## HISTORIC AND DESIGN REVIEW COMMISSION

May 20, 2020

**HDRC CASE NO:** 2020-180  
**ADDRESS:** 1335 E CROCKETT ST  
**LEGAL DESCRIPTION:** NCB 1372 BLK 4 LOT 24  
**ZONING:** C-1, H  
**CITY COUNCIL DIST.:** 2  
**DISTRICT:** Dignowity Hill Historic District  
**APPLICANT:** Linda Reyna  
**OWNER:** Sandy Morales/Generations Investment Properties LLC  
**TYPE OF WORK:** Porch decking and fence installation, landscaping  
**APPLICATION RECEIVED:** April 08, 2020  
**60-DAY REVIEW:** Not applicable due to City Council Emergency Orders  
**CASE MANAGER:** Huy Pham

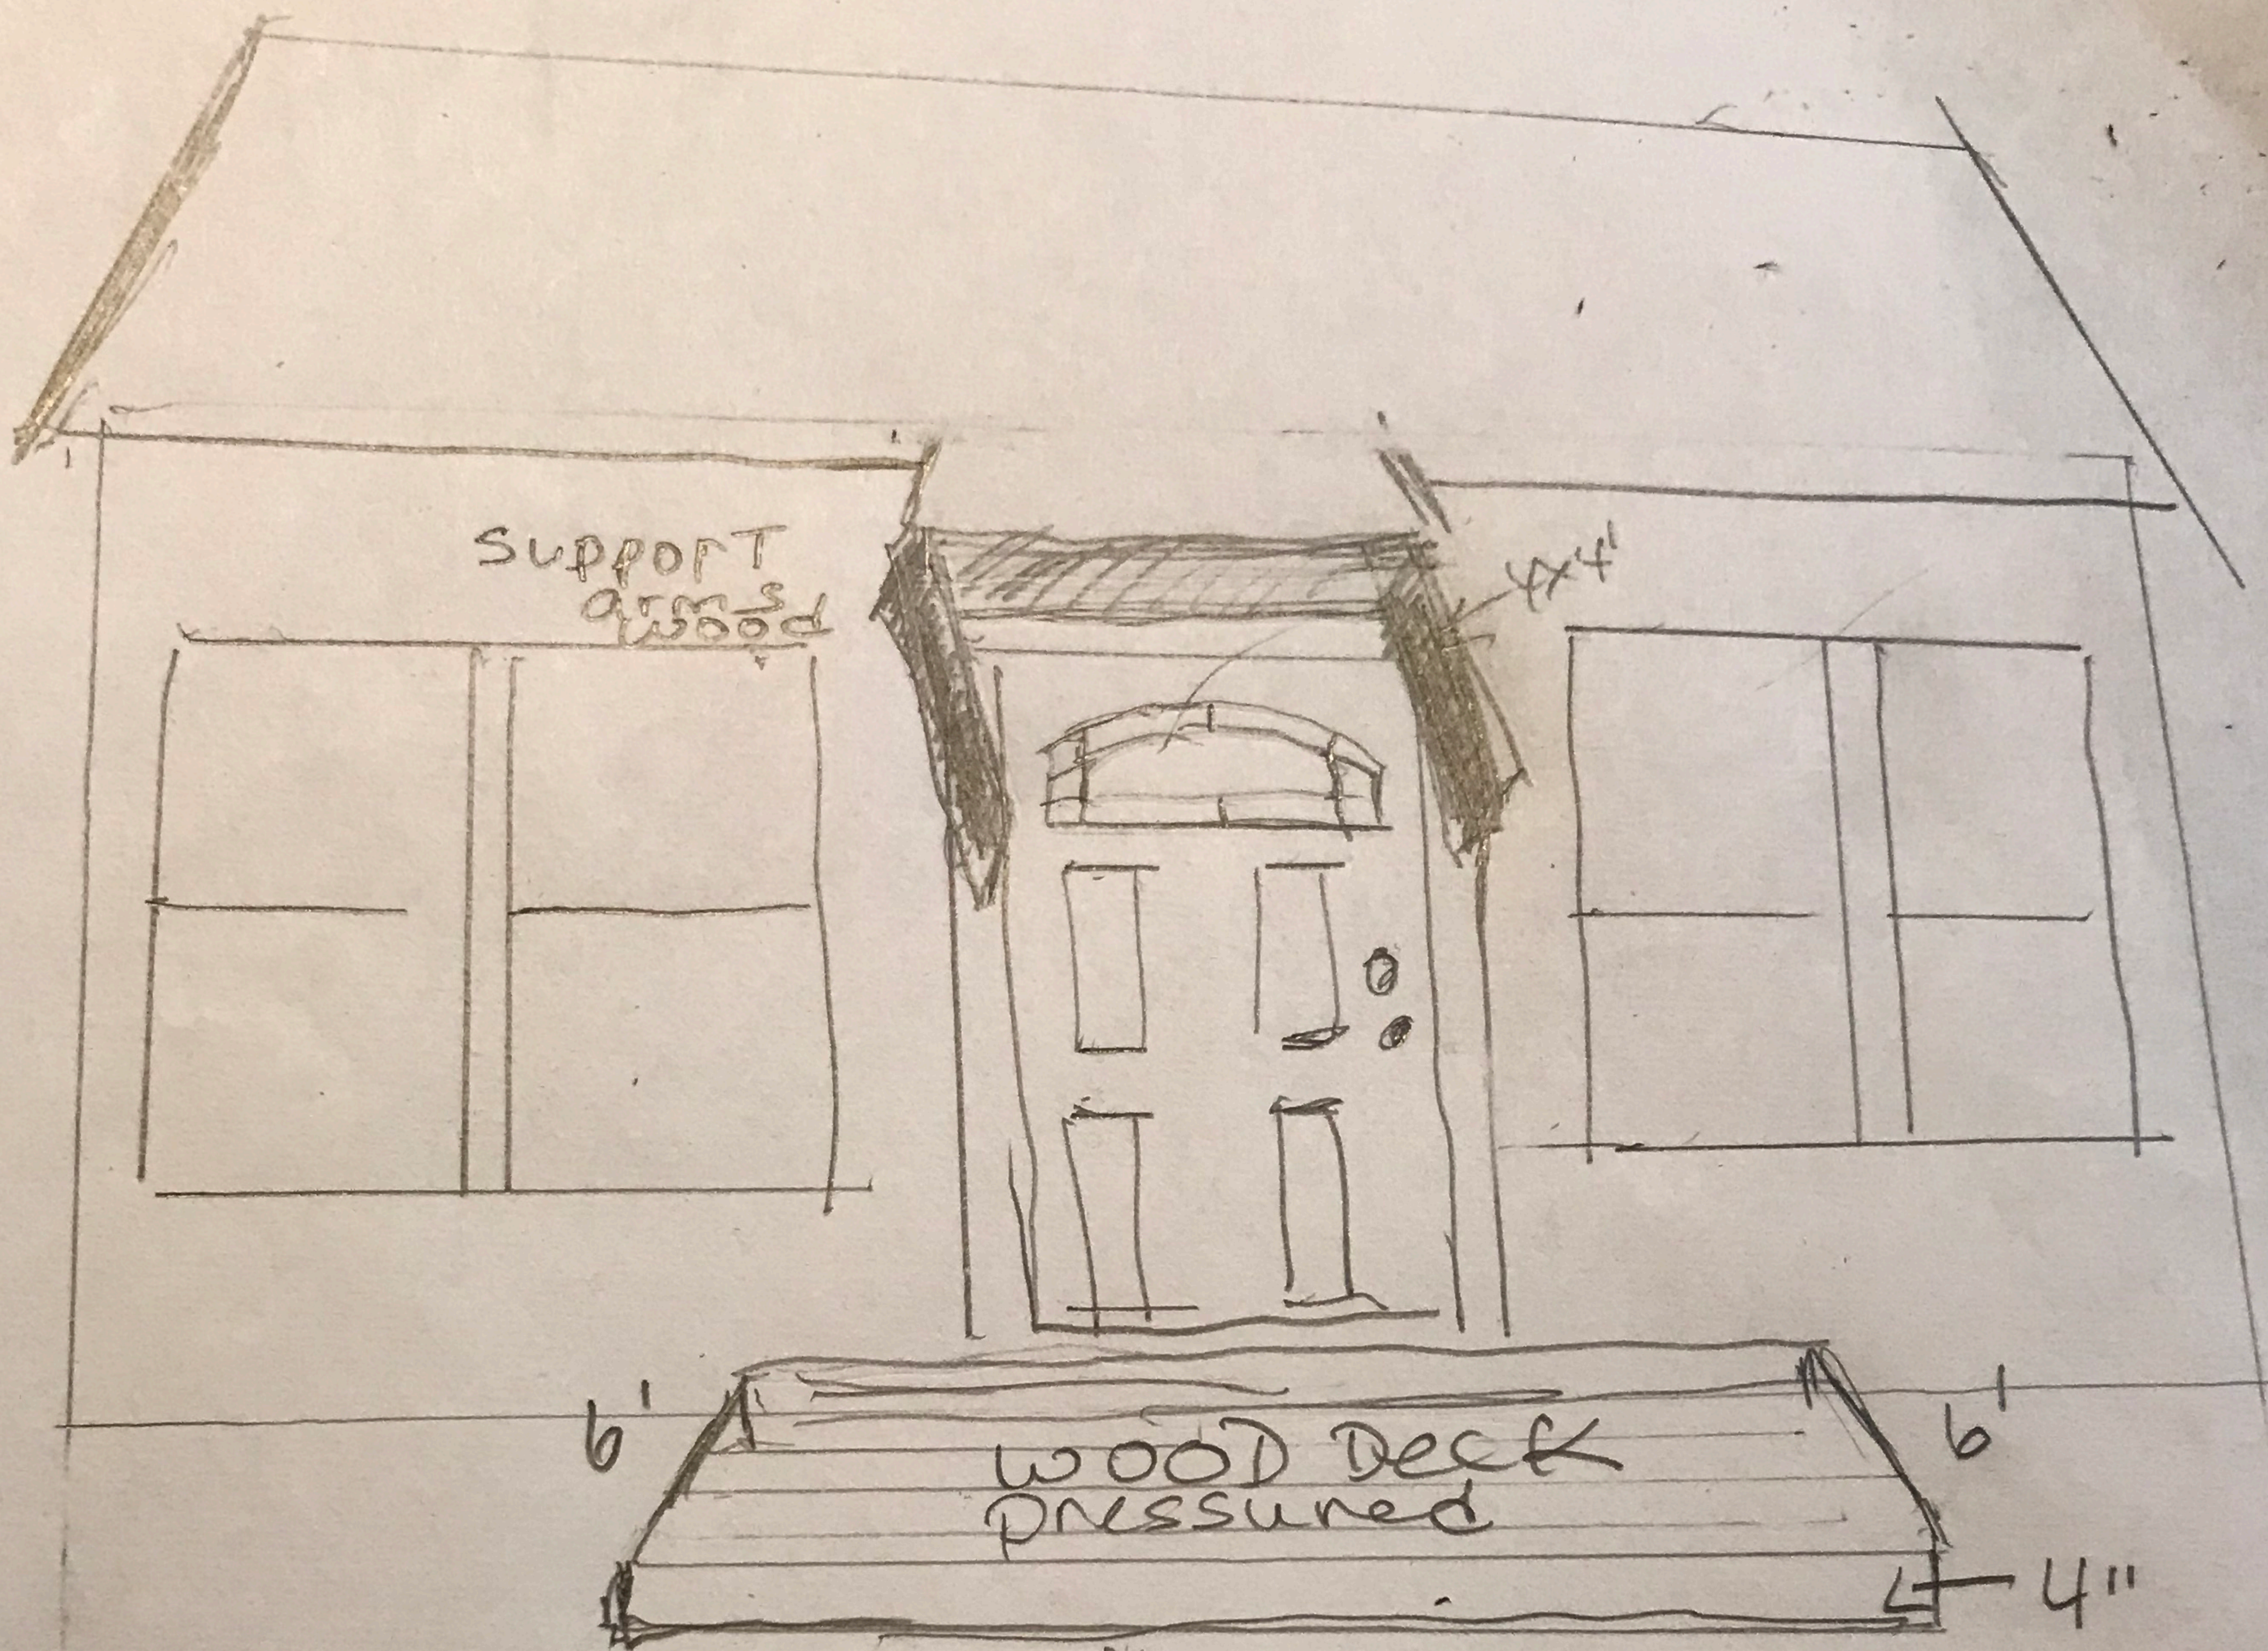
- c. FRONT PORCH DECK – The applicant has proposed to install a wood deck over the existing front concrete patio. The proposed deck features 6’ in depth, 12 to 17’ in width, 4” in height with 2”x4” decking and 4”x4” posts. Per the Guidelines for Exterior Maintenance and Alterations 7.B.v., applicants should reconstruct porches, balconies, and porte-cocheres based on accurate evidence of the original, such as photographs; if no such evidence exists, the design should be based on the architectural style of the building and historic patterns. Staff finds that the front porch deck is an inappropriate addition to a commercial cinder block structure set at grade. Staff finds the existing concrete patio should be repaired in-kind and a minimal concrete incline may be installed to meet ADA compliance per the Guidelines for Site Elements 5.A.v.

Staff does not recommend approval of item 1., the installation of wood brackets, and item 2. The installation of a wood deck based on findings b and c. If the existing door cover is subject to failure, staff recommends in-kind structural repairs instead of adding new elements. Staff recommends the existing concrete patio is repaired in-kind and a minimal concrete incline may be installed to meet ADA compliance per the Guidelines for Site Elements 5.A.v. instead of installing a deck.

# Fence Proposal

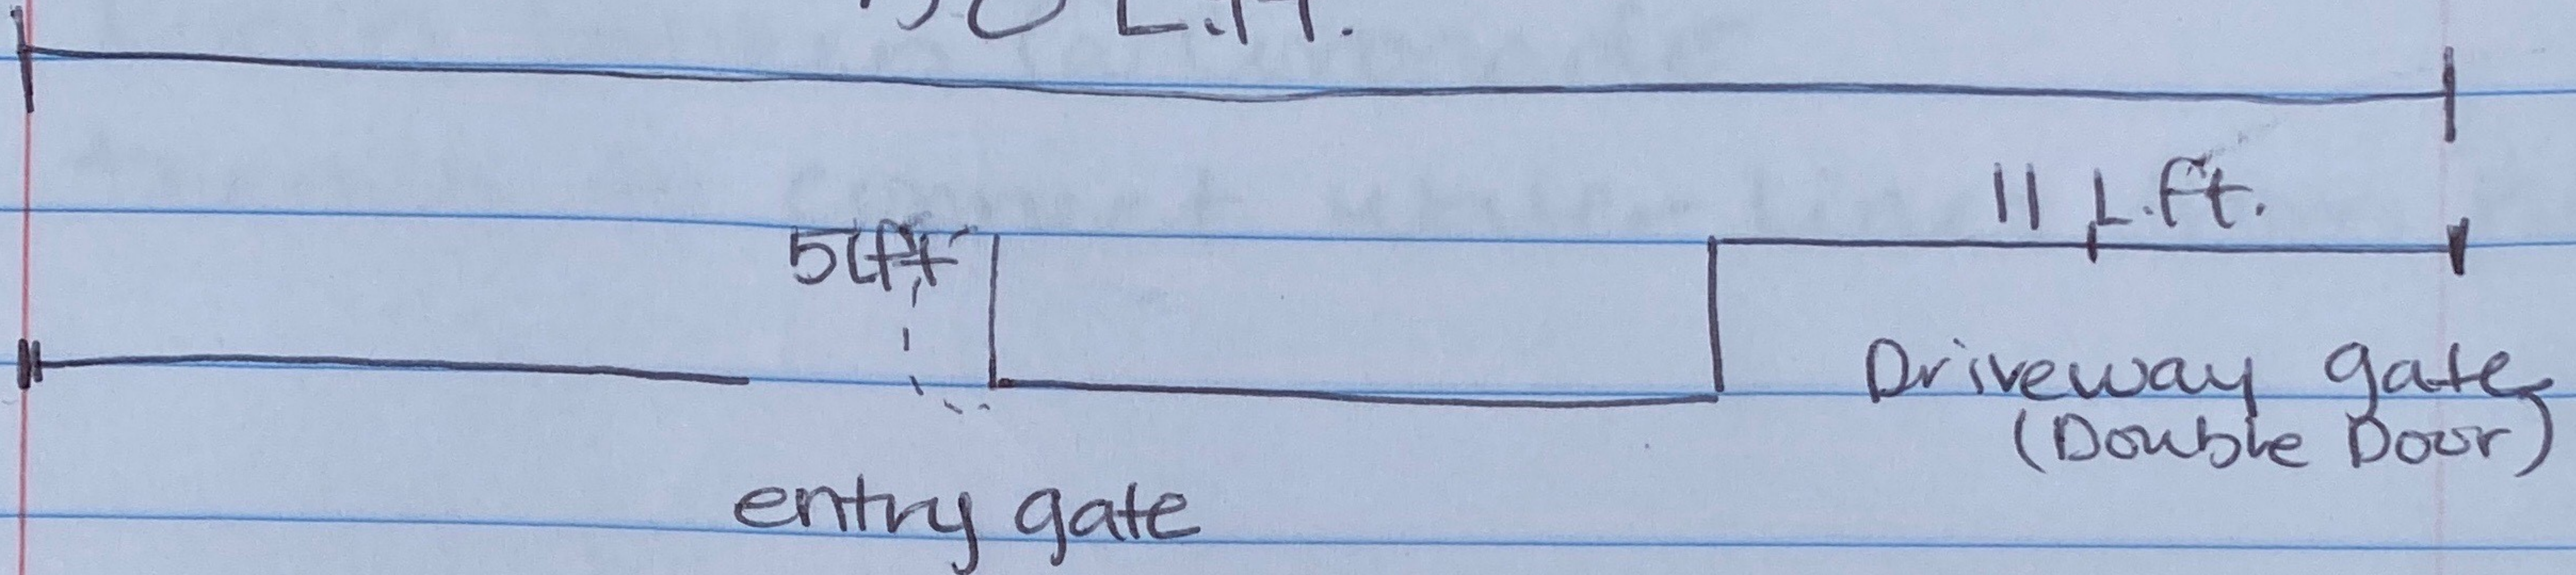
- d. FENCE – The applicant has proposed to install a cattle panel front yard fence including a front driveway gate. Per the Guidelines for Site Elements 2.B.ii., new front yard fences or walls should not be introduced within historic districts that have not historically had them. Staff finds that front yard fences are found on E Crockett and throughout the historic district, and that the installation of a front yard fence is appropriate.

- e. FENCE DESIGN - The applicant has proposed to install a wood-framed cattle panel fence. Per the Guidelines for Site Elements 2.B.i, new fences and walls should appear similar to those used historically within the district in terms of their scale, transparency, and character; the design of fences should respond to the design and materials of the house or main structure. Staff finds that the proposed fence design is appropriate to the style and location of the historic structure.

- f. DRIVEWAY GATE – The applicant has proposed to include a driveway gate spanning across the front at the property line. Staff finds that the property does not currently feature a driveway and the installation of a driveway gate would perpetuate inappropriate front yard parking.

- g. FENCE HEIGHT – The applicant has proposed to install a fence with a height of 4 feet in the front yard. Per the Guidelines for Site Elements 2.B.iii, applicants should limit the height of new fences and walls within the front yard to a maximum of four feet. Staff finds the proposed height is consistent with the Guidelines.

Staff recommends approval of item 3., the front yard fence based on findings d through g with the following stipulations:

- i. That the driveway gate is removed from the design and the fence instead spans across the front of the property
- j. That no portion of the fence exceeds 4 feet in height

## Quikrete 20 lb. Quick-Setting Cement Concrete Mix

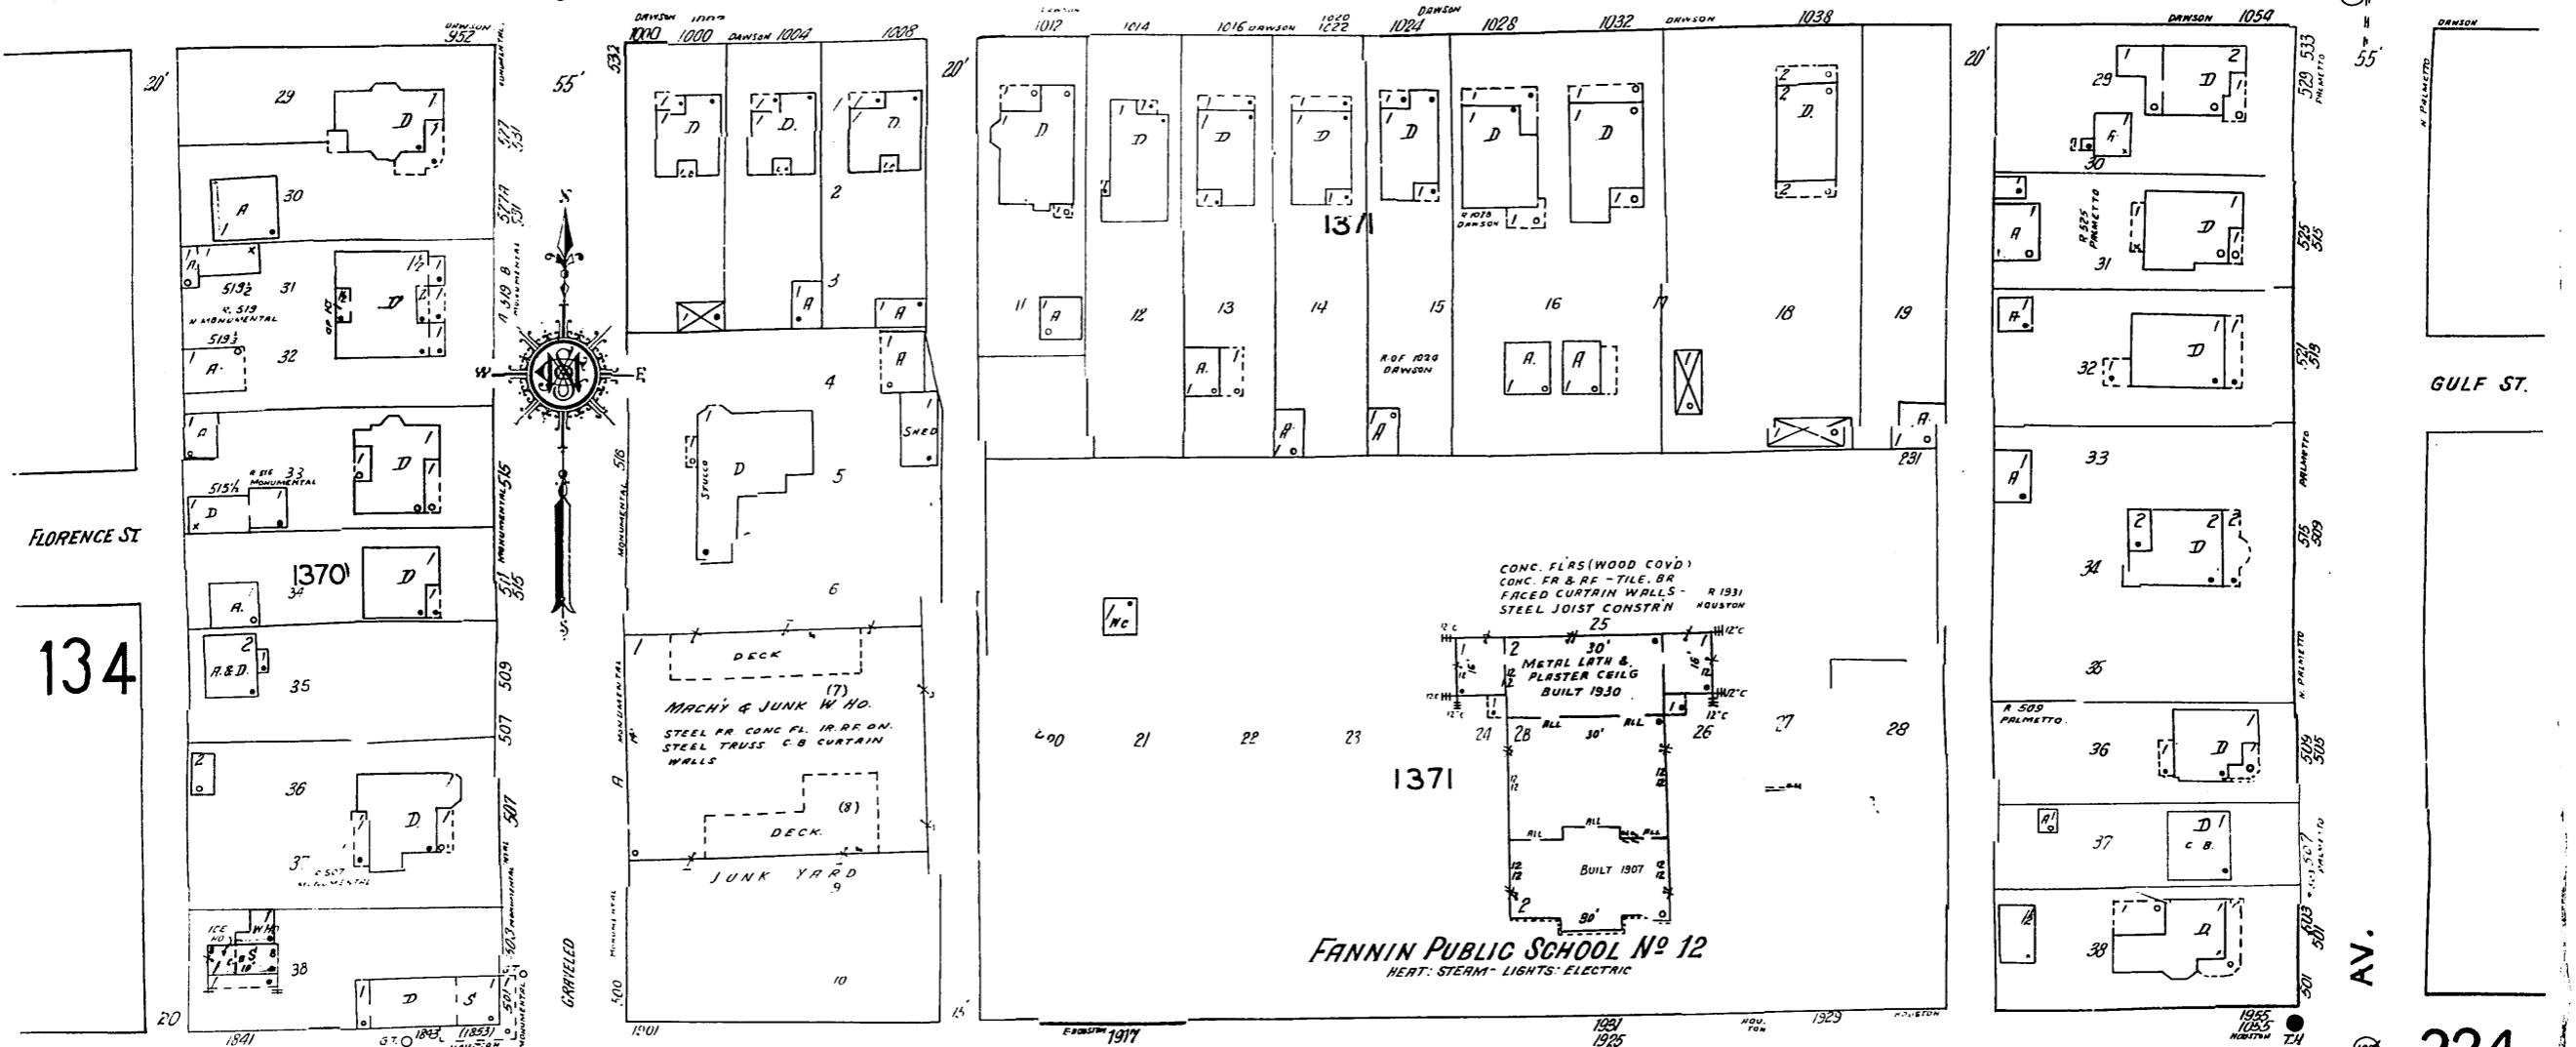
- h. WALKWAY – The applicant has proposed to repair the front concrete walkway by filling in cracks with Quickcrete. Per the Guidelines for Site Elements 5.A.i., applicants should repair minor cracking, settling, or jamming along sidewalks to prevent uneven surfaces. Staff finds the proposed treatment appropriate if the concrete patching matches the existing texture and color.

Staff recommends approval of item 4., walkway repair with the stipulation that the concrete patches matches the existing walkway in texture and color.
